CERTIFICATE OF APPROPRIATENESS

Property: 4010 Pineridge St, Lot 14, Block 124, North Norhill Subdivision. The property includes a historic 1,868 square foot, one-story wood frame single-family residence and a detached carport situated on a 5,000 square foot (50' x 100') interior lot.

Proposal: Alteration – Construct a second-floor addition beginning 25'-11" from the front wall of the structure and a two-story side addition to the previously constructed two-story addition at the rear.
See enclosed application materials and detailed project description on p. 4-22 for further details.

Recommendation: **Partial Approval: Denial to construct the second-story addition located on the original brick structure. Approval for all other proposed work.**

3D RENDERING – FRONT FACING PINERIDGE STREET

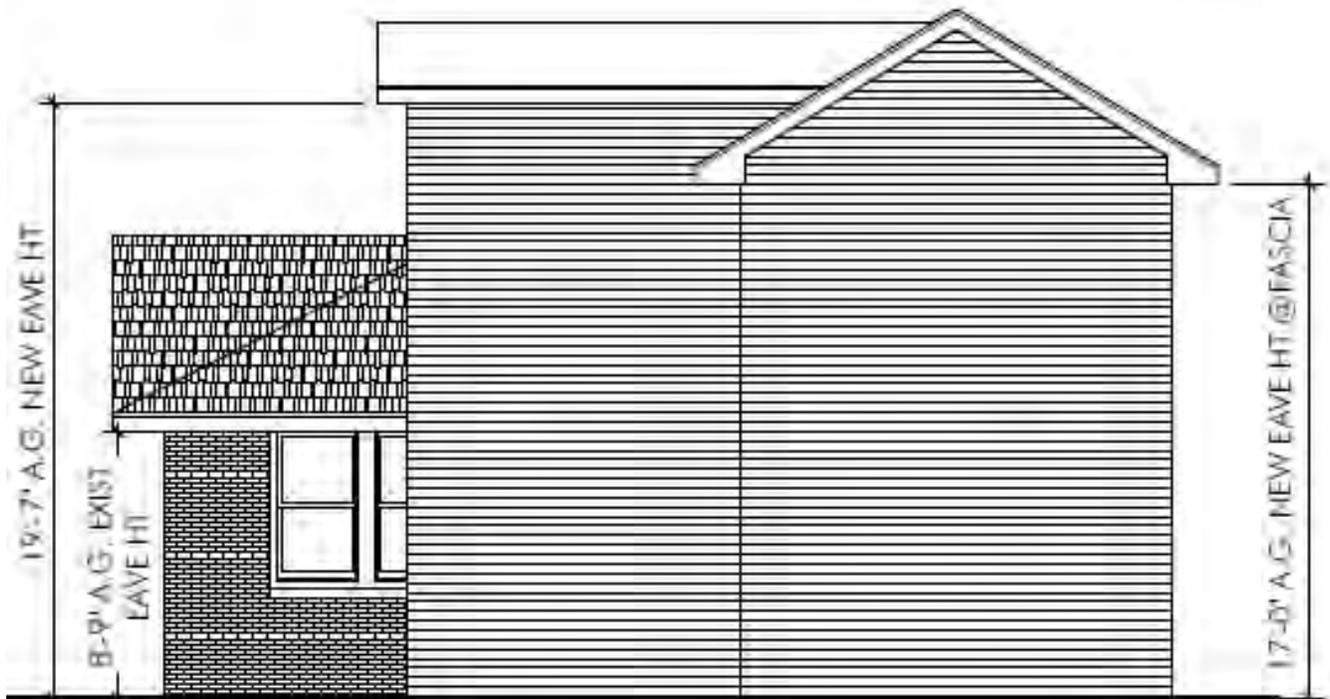
<i>The encroachment of the second-story addition onto the original structure does not retain the historical character of the property as a one-story structure.</i> |

<i>The second-story addition on the original structure alters the character of the structure as well as disrupts the rhythm of the blockface that contains all one-story bungalows due to its increased visibility from the street.</i> |

<i>The second-story addition on the original structure impairs the form and integrity of the house. The walls beneath will have to be reframed to carry the extra-load which results in the removal of interior shiplap as well as compromises the integrity of the brick cladding and original windows below.</i> |

<i>The original structure will have to be reframed which will destroy shiplap as well as compromise significant materials such as the windows and brick. The second story-addition also alters the form of the one-story bungalow and is not compatible with the one-story bungalows in the area.</i> |

Second, we purchased the home with the existing second-story addition, which is visible from the street (although not while standing in front of the house). The proposed design mimics the existing design, so it cannot be said that the two-story addition "disrupts the rhythm of the blockface that contains all one-story bungalows." Our home is already two stories and the proposed correction to, and slight expansion of, the existing second-story does not materially increase its current partial visibility. As shown in our drawings, from a street view, the property maintains the same historical character as currently exists.

However, the integrity of the home is important to us, and the architectural plans as submitted and later correspondence plainly show that the proposed addition *preserves* both the brick exterior *and* existing windows. To be clear, there will be no impact on the brick exterior or existing windows. This was carefully considered when the project was designed. There is nowhere else inside the home where stairs can be added that disrupts as little of the original floor plan as what we propose. As noted in prior submissions, as the homeowners, our full intent is to reuse all original shiplap where possible. Even if we didn't, the plan includes no alteration to the exterior brick or windows. The basis of this claim is a mystery. Regardless, the form of the front half of the house (i.e., one-story bungalow) will remain unaltered.
